Knottingley Proposed Power Plant Order

Applicant's Supplemental Statement of Common Ground with Canal and River Trust Concerning Water Resources Issues

Document Reference: KPL/Ex/23

Statement of Common Ground

Figure 1: Power Station Abstraction from the River Aire

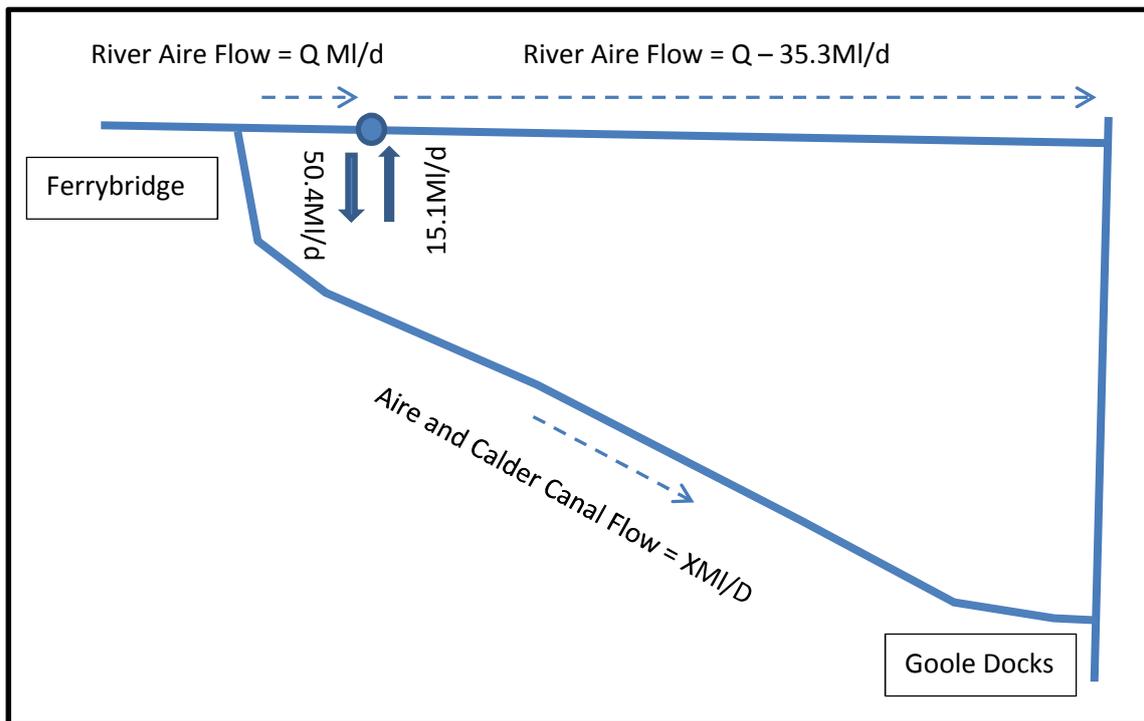
The Applicant and CRT agree that an abstraction of 50.4 MI/d and a return of 15.1 MI/d by Knottingley Power Ltd from the river will result in flows along a stretch of the River Aire (downstream of the abstraction) being reduced by 35.3 MI/d. This is shown in figure 1 below.

Figure 2: Power Station Abstraction from Aire and Calder Canal

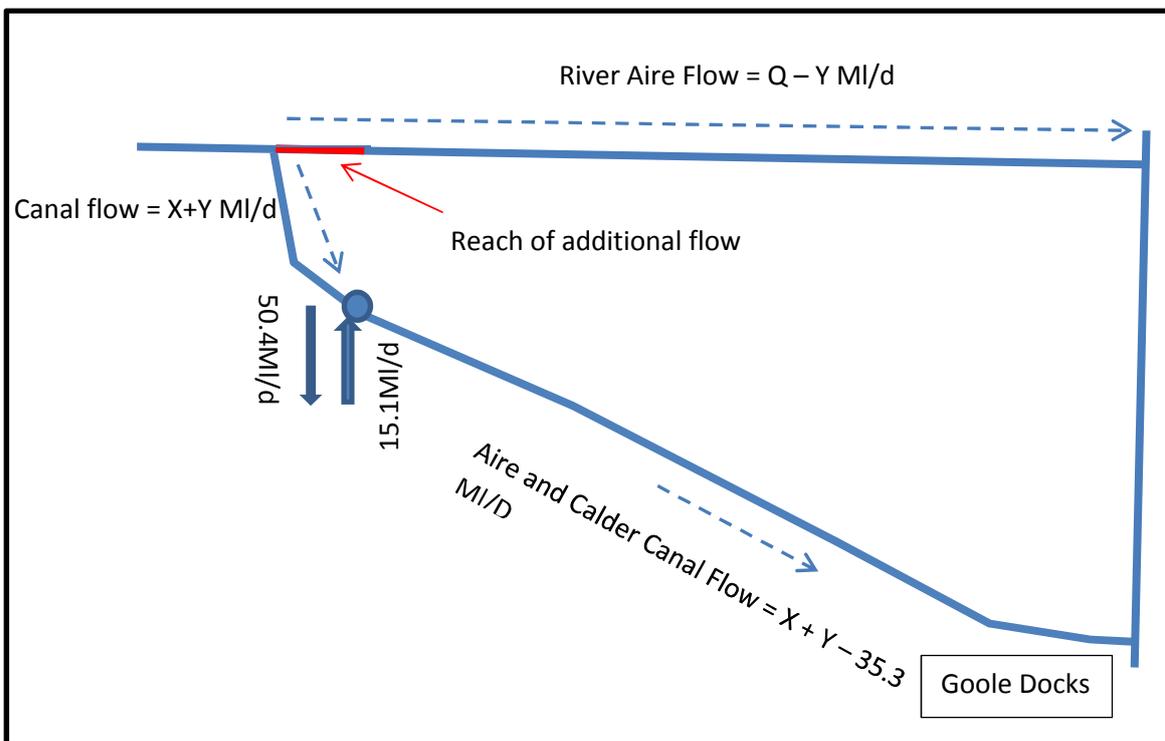
There is however disagreement between the Applicant and CRT as to the maximum level of flow reduction that would occur.

CRT believe that the reduction along this reach would be the same as for abstraction from the river (i.e. Figure 2, $Y=35.4$ MI/d); while the Applicant maintains that to avoid significant thermal impacts in the canal more water would need to be diverted into the canal and therefore the reduction in flow in the river will be greater (i.e. Figure 2, $Y>35.4$ MI/d). CRT maintain that the level of flow reduction along the 1.8km of river based on its own calculations would have only a negligible environmental impact and has not seen any evidence to suggest that any more water would need to be diverted into the canal but would be happy to review any such evidence.

Figure 3: Comparison of Model Results Close to the Discharge Outlet

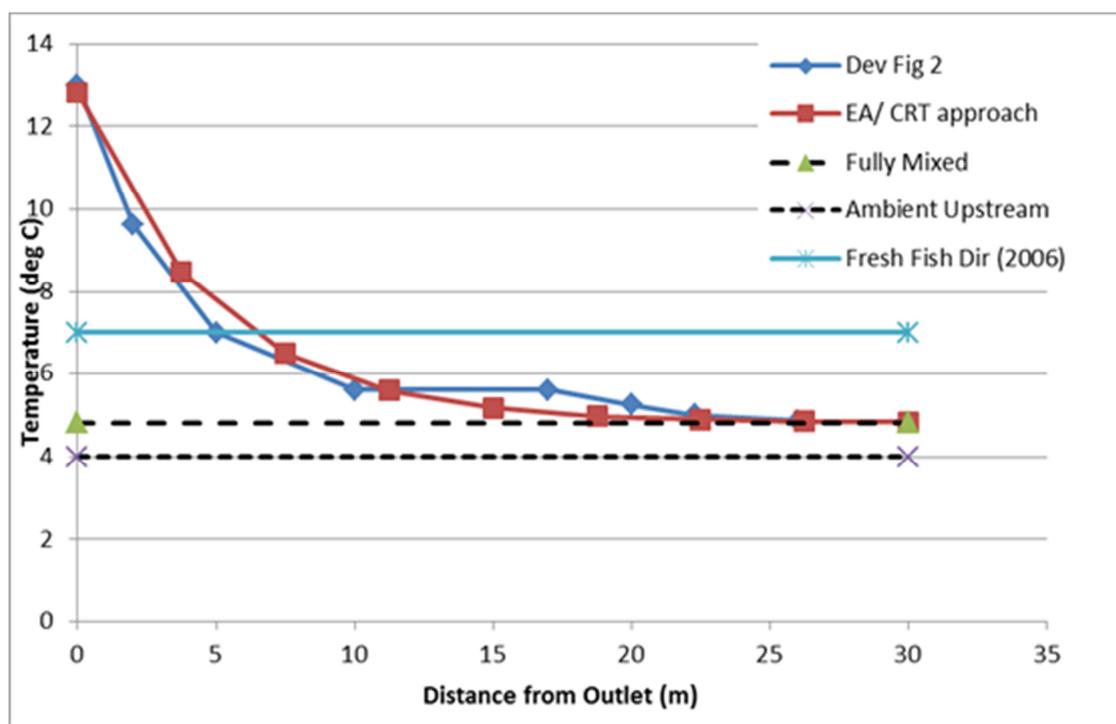
The Applicant and CRT agree that the respective appraisals of thermal dilution of the plume in the canal produce very similar results when the same input parameters are entered (Figure 3). There is however disagreement as to the correct input parameters and this alters whether or not the fully mixed situation yields a temperature rise less than 3deg C which is a requirement to satisfy the Freshwater Fish Requirement (2006). CRT has not seen any evidence to suggest that the input parameters it has provided are incorrect but would be happy to review any such evidence

From the above the Applicant and CRT agree that the predicted plume temperature reaches 3 degrees above ambient approximately 5-7 metres from the discharge point for this specific scenario which relates to observed flows on one specific day (when monitoring was undertaken) which followed a period of heavy rain. There is however disagreement as to the size of the thermal plume and significance of impacts within the canal in relation to the cyprinid fishery under low flow conditions.
